Technical Note TN7a

800 series PSU exchange: XP to UMEC

This note details the electrical changes required when fitting an “XP” PSU to a product previously fitted with a “UMEC” type. The PSUs are not pin compatible, so the connecting wires must be re-arranged.

New-type PSU: XP ECM40UT31

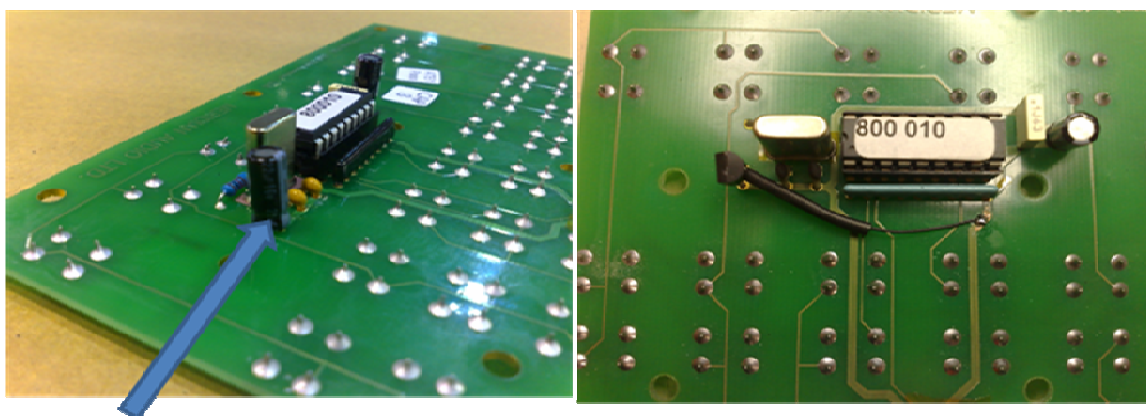
The connecting wires must be re-arranged into the order shown in the following picture.

Red, Red (5V), Black, Black (0V), Blue (-12V), Yellow (12V).

The power supply is factory set at 5.2 Volts. Check the voltage after installation. If it is not 5.2V, the output should be adjusted using the trimmer located adjacent to the 6-way header.
